SERVICE BULLETIN

SB No. 68 Issue No. 3

TITLE
CANOPY LATCH CORRECT OPERATION INSPECTION
CLASSIFICATION

T67C, T67M and T67M200 Aircraft, Post Mod M129 (Split Canopy), T67M-MkII, T67M260 and T67M260-T3A.

Fig 1

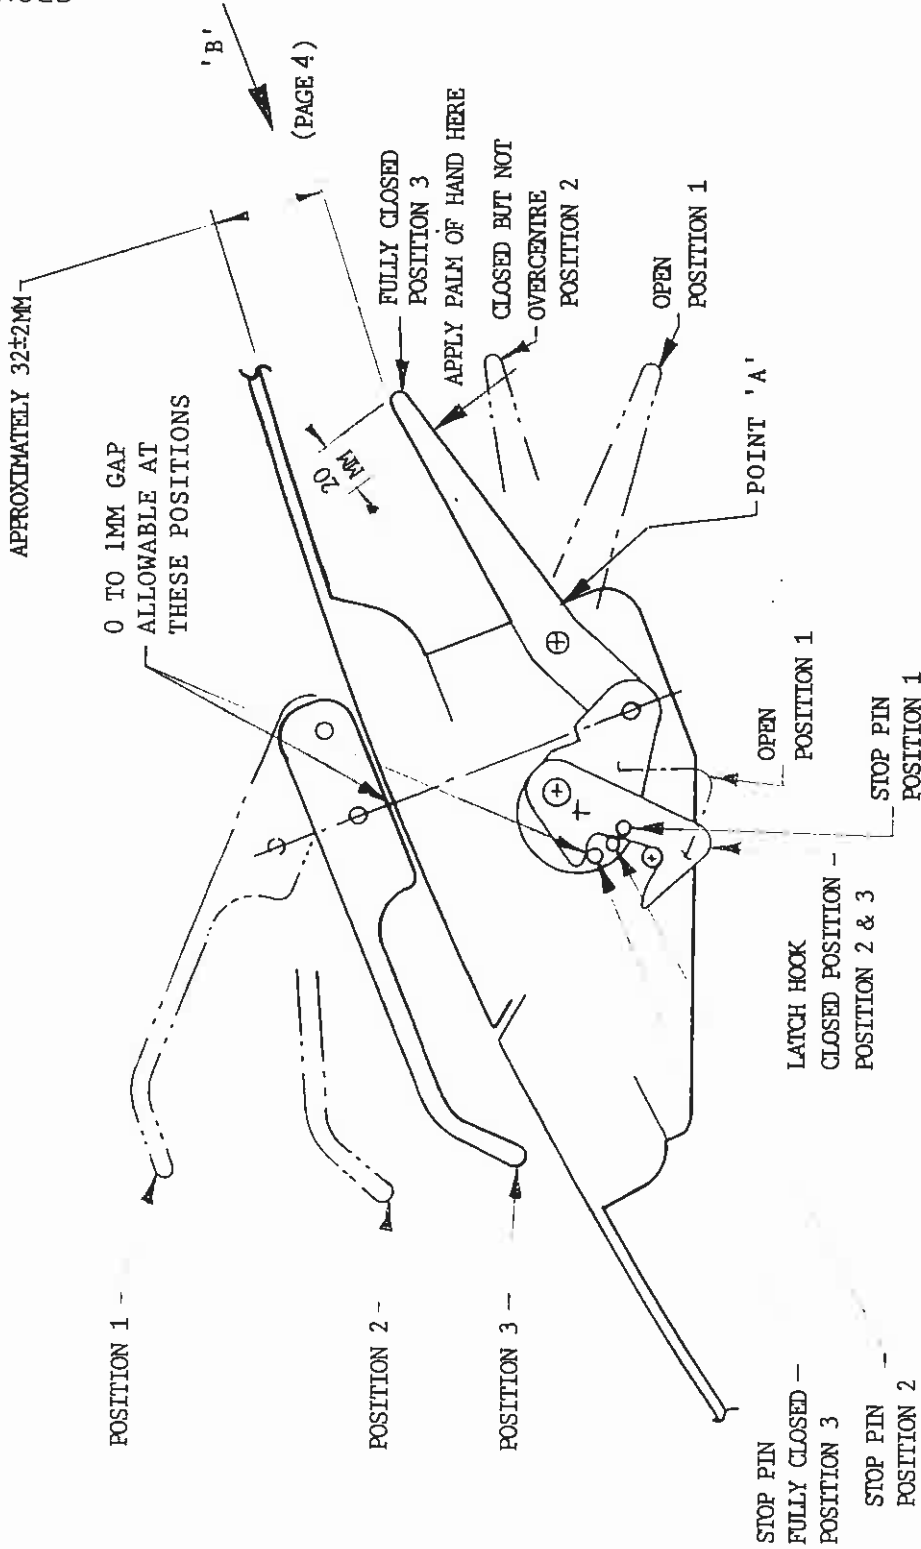
Fig. 1 page 2 shows 3 positions of the canopy mechanism:

Position 1 - Open/Unlatched

Position 2 - Latched but mechanism not over centre

Position 3 - Correctly closed, mechanism fully over centre.

- (i) Remove canopy mechanism and latch covers
- (ii) Close canopy fully. Ensure internal handle is in its correct position and external handle is in its correct position, ie touching bush or no more than 1mm gap. Fig. 1.
- (iii) Check that stop pin is just touching latch hook or no more than 1mm from it. If not adjust in accordance with Maintenance Manual, Section 3, paragraphs 3.2.
- (iv) If (ii) and (iii) cannot be met after adjustment, then it is acceptable to slot latch block Ref. Fig. 3. Suitably re-protect cut surfaces and re-identify block as Part Number T67G-17-531 Post Mod M713B. Annotate Logbook accordingly.
- (v) Check closure. By positioning palm of hand at point indicated, ref. Fig. 1, push up latch handle, which should close with reasonable resistance but without using excessive force.

- (vi) Replace mechanism and latch covers, in accordance with Maintenance Manual, Section 3, paragraphs 3.2.
- (vii) Maintenance Manuals to be amended to reflect points contained in (ii), (iii), (iv) and (v).
- (viii) When handle is fully closed, ie meets requirements of Fig. 1, mark a white line across both labels ref. Fig. 2 on line with handle lower surface (ie coincident with Point 'A' ref Fig. 1 & 2. The line may be obtained by running a hacksaw across both labels; a) deep enough to reveal white of label material or b) if base material is red, deep enough to hold white fill in wax, ie 0.25mm to 0.5mm.

FIG 3

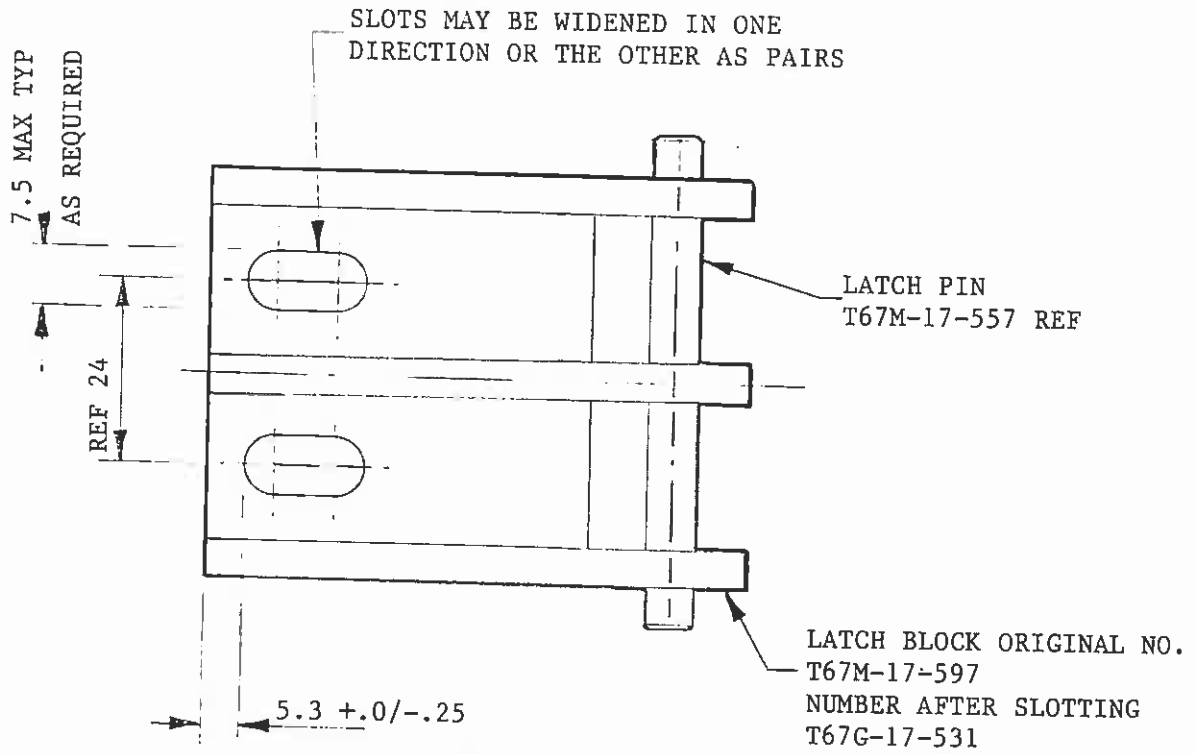
When label is marked, it is to be identified in IPC Ref. Chapter 15 as Part No. T67M-17-351 Post Mod M666, Part No. T67M-17-319 to be annotated Pre Mod M666. Annotate Logbook Mod M666 incorporated.
